Resource consent application – Further information request

Application number(s): BUN60440759 (LUC60440790, LUC60445125 & DIS60440791)
Applicant: Scarbro Environmental Ltd
Address: 362 Jones Road, Drury
Proposed activity(s): To establish and operate a managed fill activity for the deposition of approximately 790,000m³ of fill.

This letter is a response to the further information dated 09 September 2025. Response prepared by Hodgson Planning Consultants and Fraser Thomas Ltd.

Figure 2: Stormwater Flowpath Routes from Fill Site (from FTL drawing 33250/501)

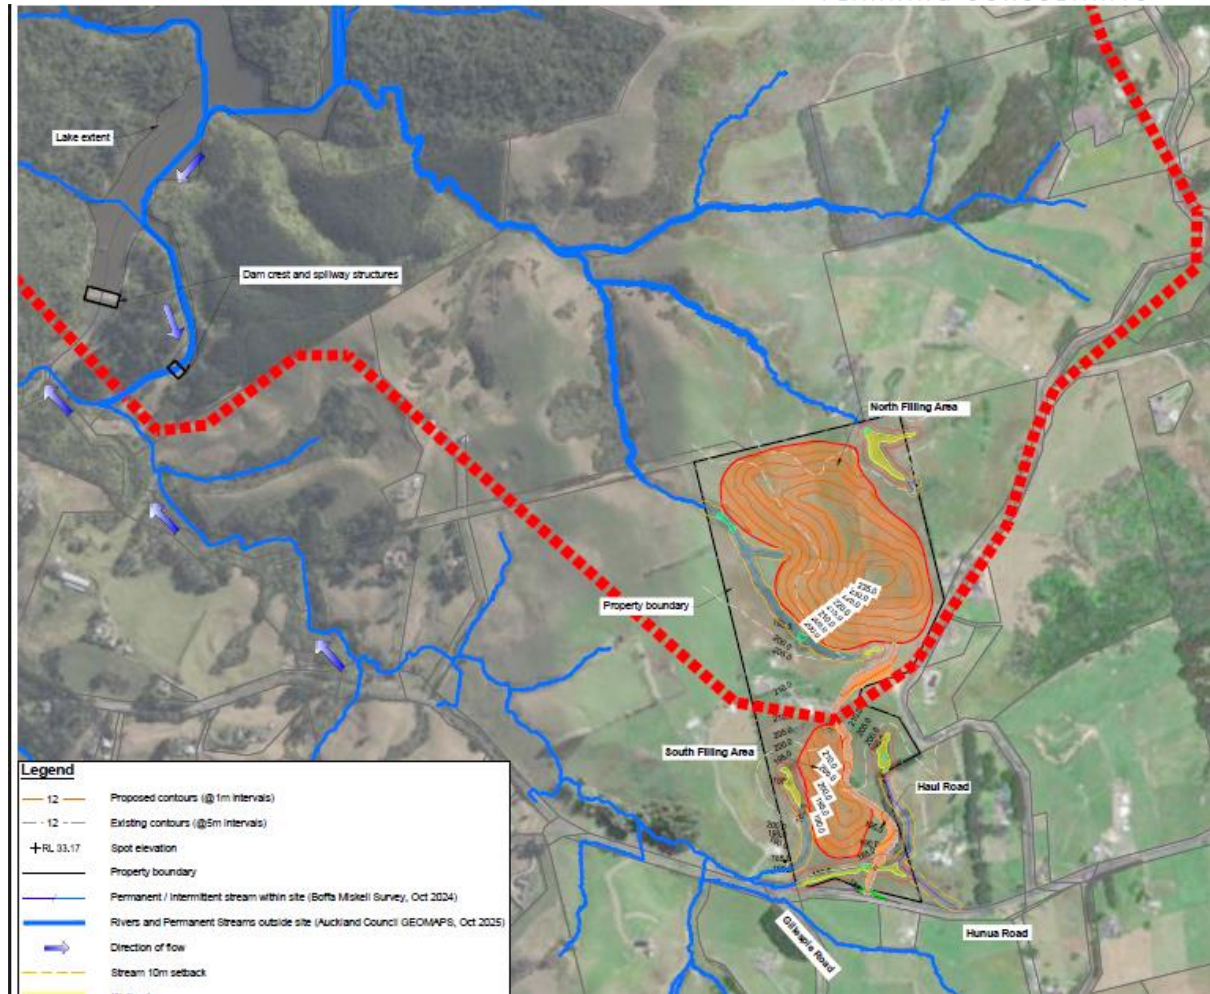
In their submission, Watercare raises three specific matters of concern that they consider are not addressed in the consent application:

- Effect of discharges from underfill strip drains proposed beneath the fill areas.
- Actual and/or potential contamination effects of runoff from the portion of the proposed haul road that is within the Hays Creek dam catchment.
- The risk to the water supply catchment from contaminants is wider than those considered in the application. It notes that runoff will carry sediment and contaminants into drains and streams, while contaminants from the fill may also migrate through the soil and shallow groundwater via interflow, which can carry pollutants downslope towards the dam, especially in areas with fractured geology or underlying faults that facilitate subsurface movement. They further note that the proposed Fill site is underlain by a fault, which whilst not active presents a potential pathway for the migration of contaminants from the fill activity.

The Northern Fill site is located at the southern end of the Hays Creek catchment and makes up 1.3% of the Hays Creek catchment area, while the shortest flowpath from the Fill area to the Hays Creek dam lake is approximately 1.3km. The Southern Fill site discharges stormwater via a different route, which bypasses the Hays Creek dam. This is shown on FTL drawing 33250/501 and in Figure 2 below.

Figure 3: Haul Road Stormwater Treatment Swale and Wheel wash facility (from FTL drawing 33250/190)

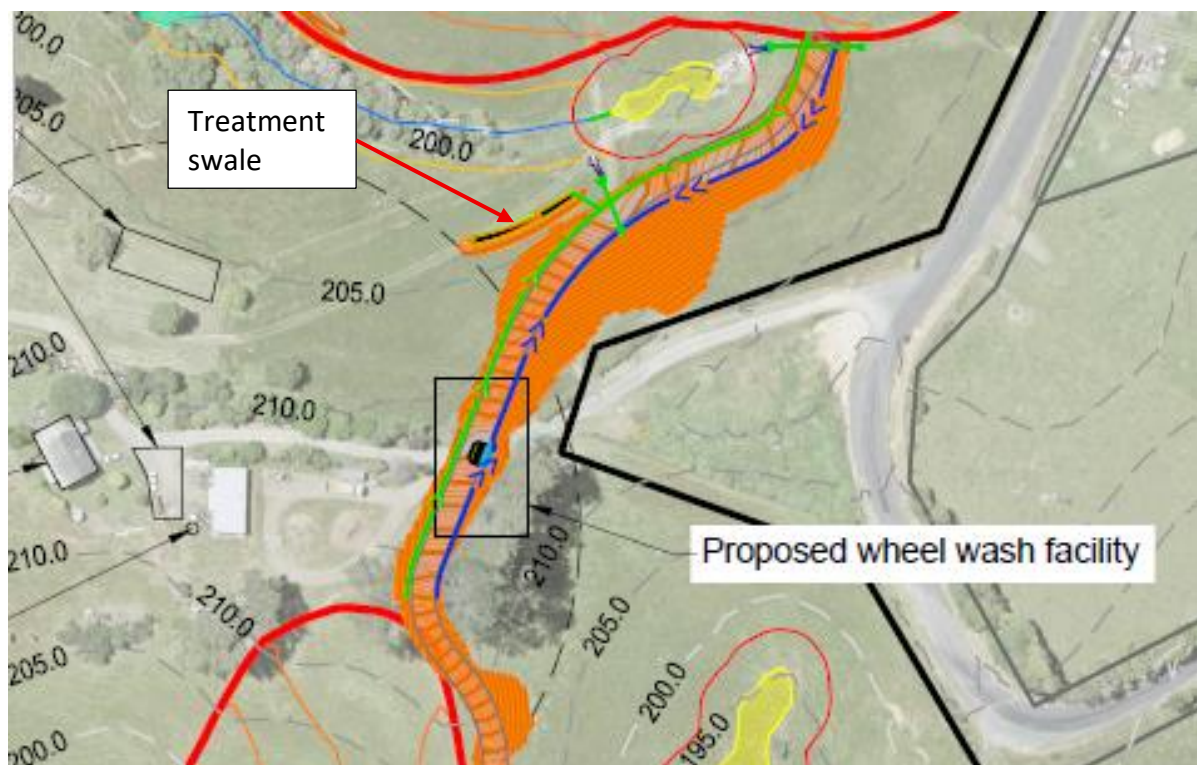
Issue: *The actual and/or potential contamination effects of runoff from the proposed haul road which will cross an existing overland flow path within the site that conveys runoff to a gully and stream that ultimately discharges to the Hays Creek Dam.*

The extent of the haul road of concern is approximately 180m x 6.2m wide. To address Watercare’s concerns, it is proposed to construct a clean water diversion drain on the uphill side to divert runoff from crossing the road, and grade the road with a single crossfall to the downhill side. Runoff from the road will be collected in a table drain and then treated in a swale further downhill, with the treated runoff being discharged to the gully (Stream 3) within the northern catchment. These details are shown on FTL drawings 33250/190 and 202.

It is also proposed to install a proprietary wheelwash, that recycles water, with estimated water losses of 25L/vehicle. Any lost water will be collected in the same table drain and conveyed to the same swale for treatment. These details are shown on FTL drawing 33250/190.

Figure 4: Excerpt from geology map showing site location with reference to Hunua Fault

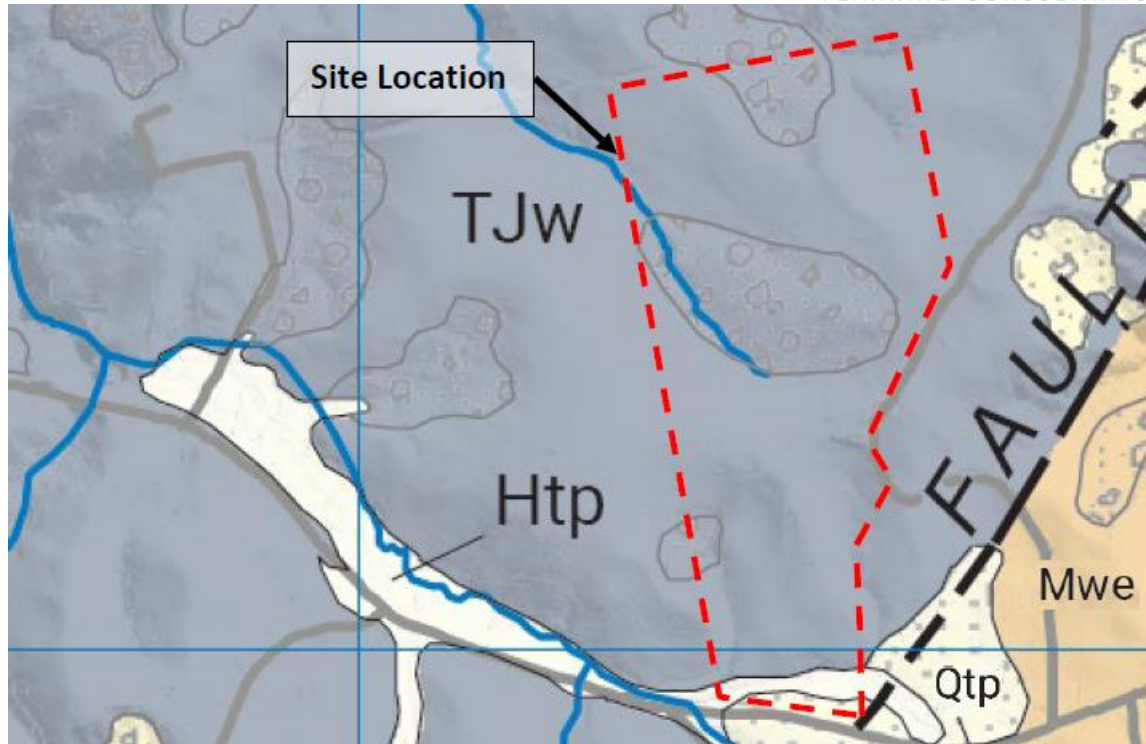
B4.2 Issue: Potential Contaminant Migration Pathway via Inactive Fault

As discussed in Section 3.0 of the October 2024 report, the geological map indicates, as shown in Figure 4 below, that the Hunua Fault is located approximately 200m to the east of the subject site. It is therefore noted that, with reference to the plan provided in the Watercare submission, the Hunua Fault location is incorrectly annotated on the plan.

It is reiterated that, as outlined in the FTL October 2024 geotechnical report, given the north-east trending Hunua Fault is mapped outside the development area, and is generally considered to be inactive (as shown in Figure 5), the Hunua Fault is unlikely to require additional consideration.
